Re: Evaluation of Appendix IX+3 Constituents and Revised Soil Removal Limits for Parcel K10-16-3 (Site No. GEACO210)

REMEDIAL ACTION WORK PLAN

**PARCEL K10-16-3
PROPOSED SOIL REMOVAL LIMITS**

FIGURE 1

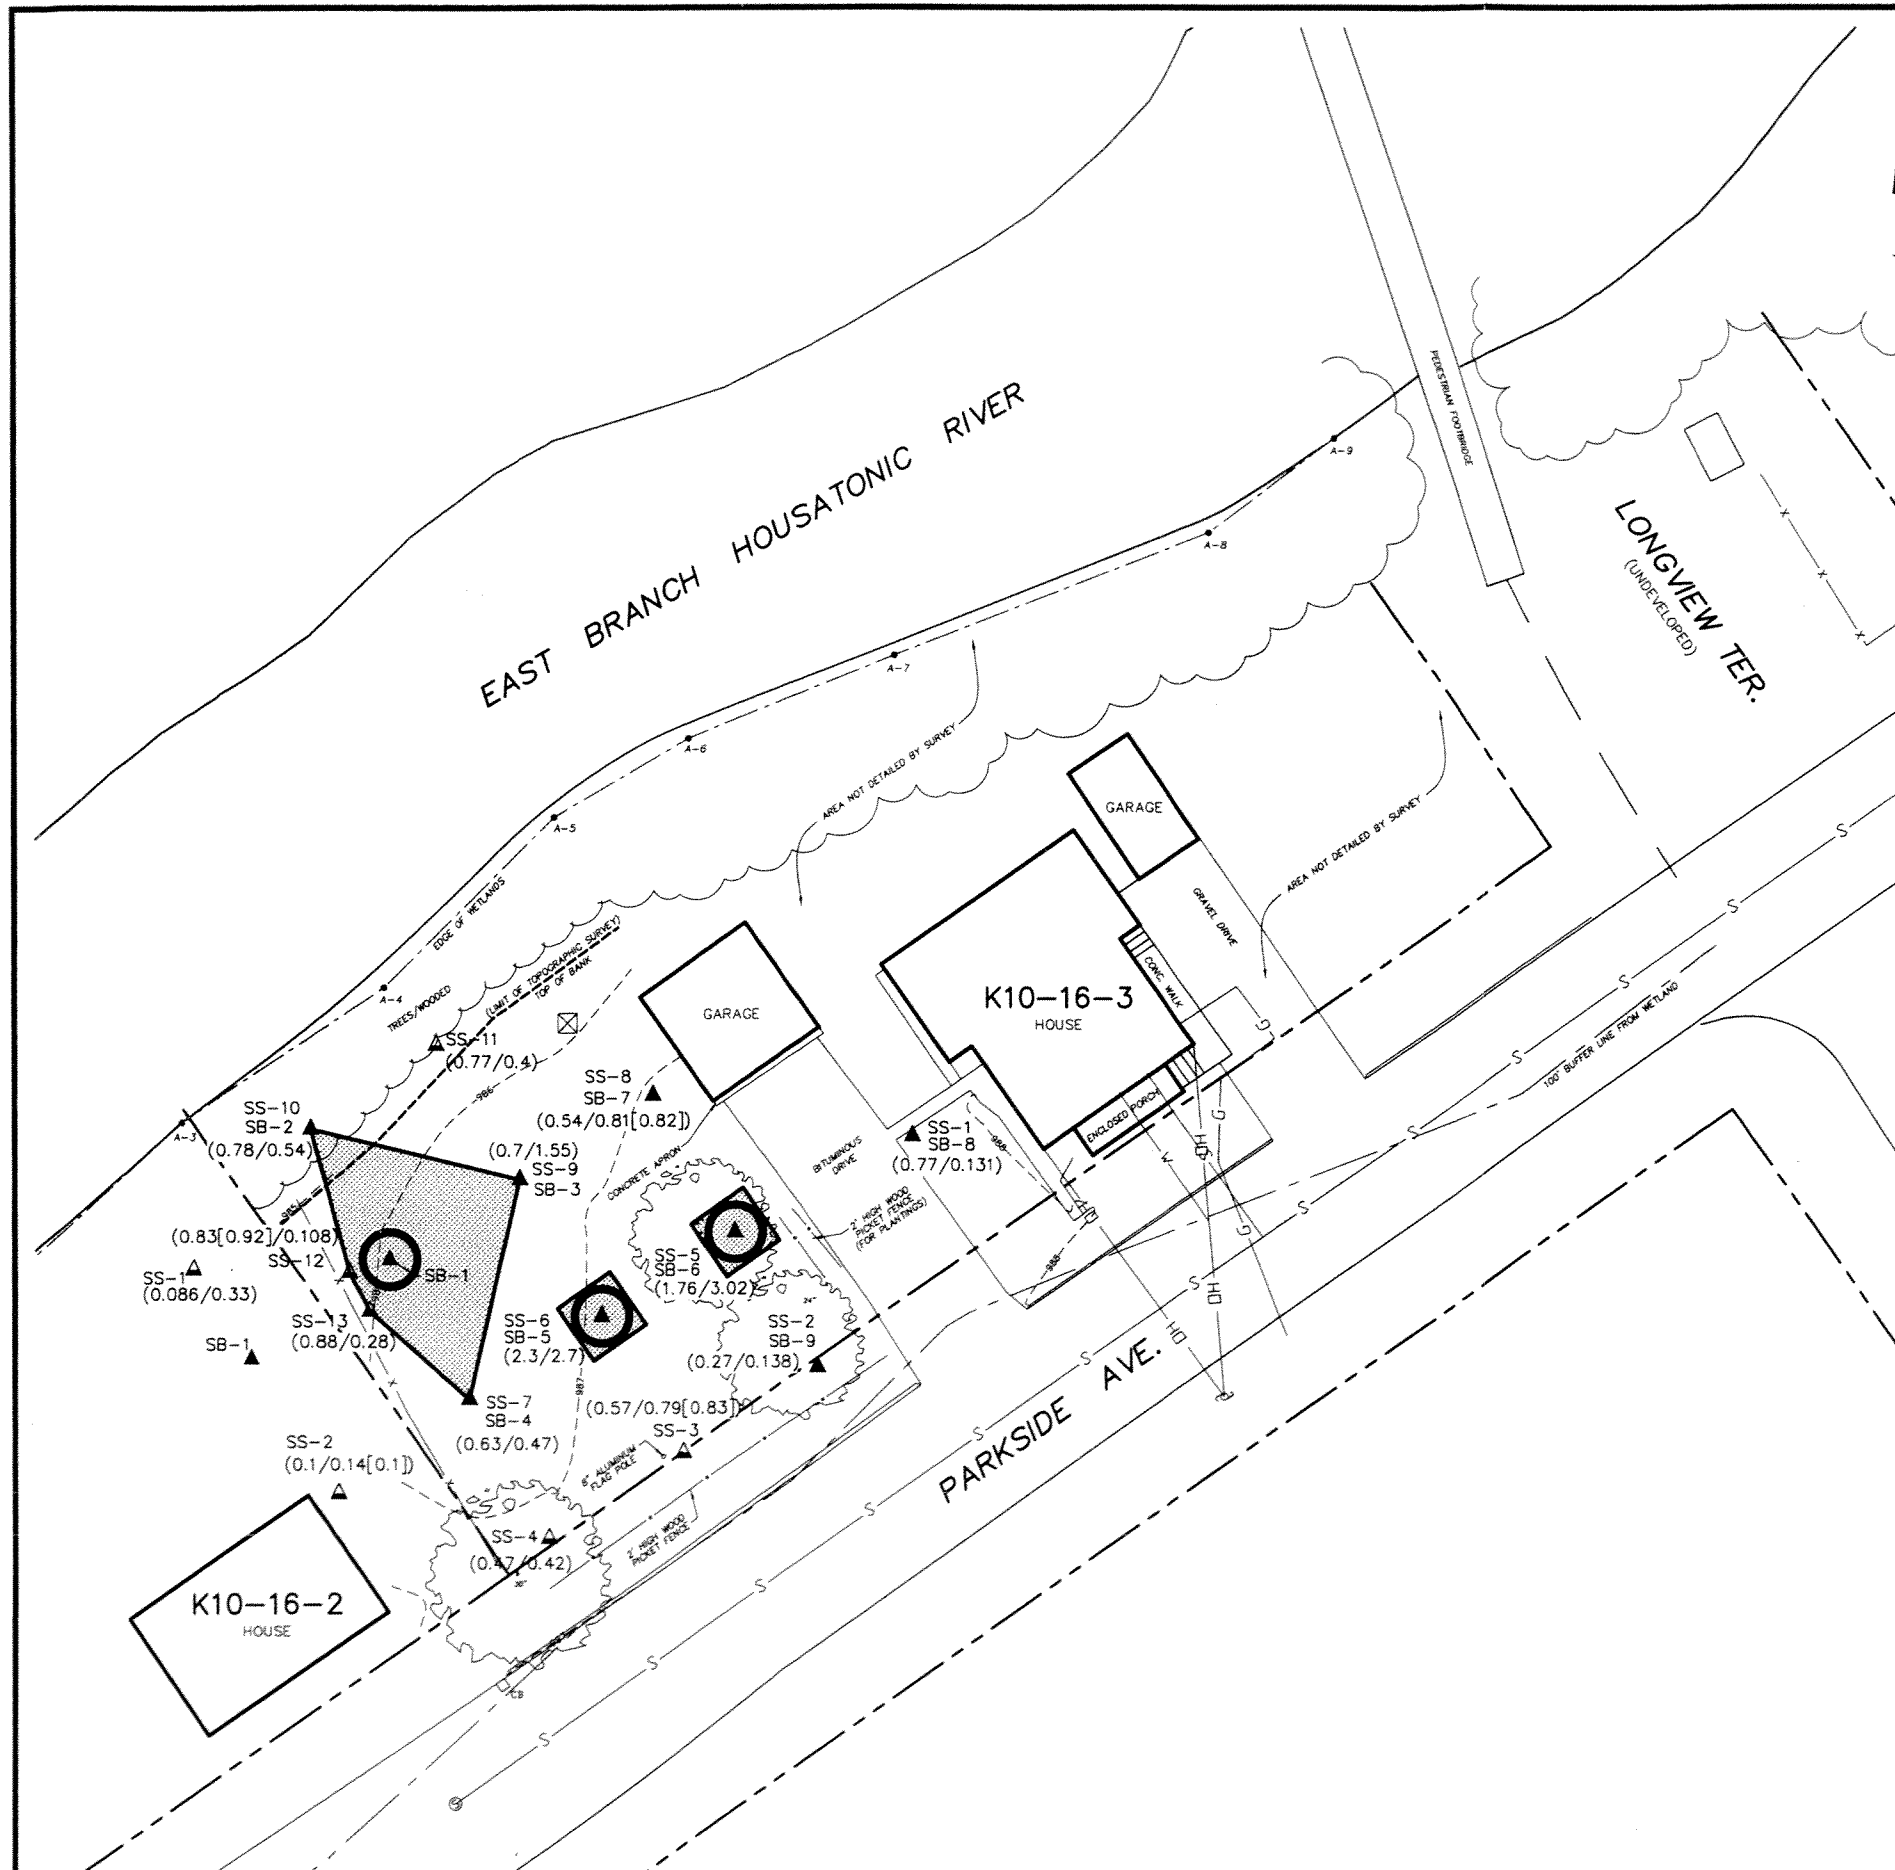
The evaluation for Parcel K10-16-3 indicated that soil removal is necessary at each of the three locations where Appendix IX+3 soil samples were collected. However, soil removal to address PCBs was already proposed at one of these sample locations -- K10-16-3-SB-1. At the other two locations, additional soil removal is proposed, consisting generally of removal of the upper one foot of soil from 10-foot by 10-foot boxes centered on the appropriate sample locations. The additional soil removal associated with the Appendix IX+3 data at these sample locations has been incorporated into revised soil removal limits, which are presented on Figure 1.

The proposed soil removal will result in the additional excavation and disposal of approximately 10 cy of soil from Parcel K10-16-3. Therefore, the revised soil removal volume attributed to PCB and non-PCB constituents at Parcel K10-16-3 is approximately 40 cy. The evaluation and additional soil removal proposed in this document will support the filing of a Class A-2 RAO Statement for Parcel K10-16-3.
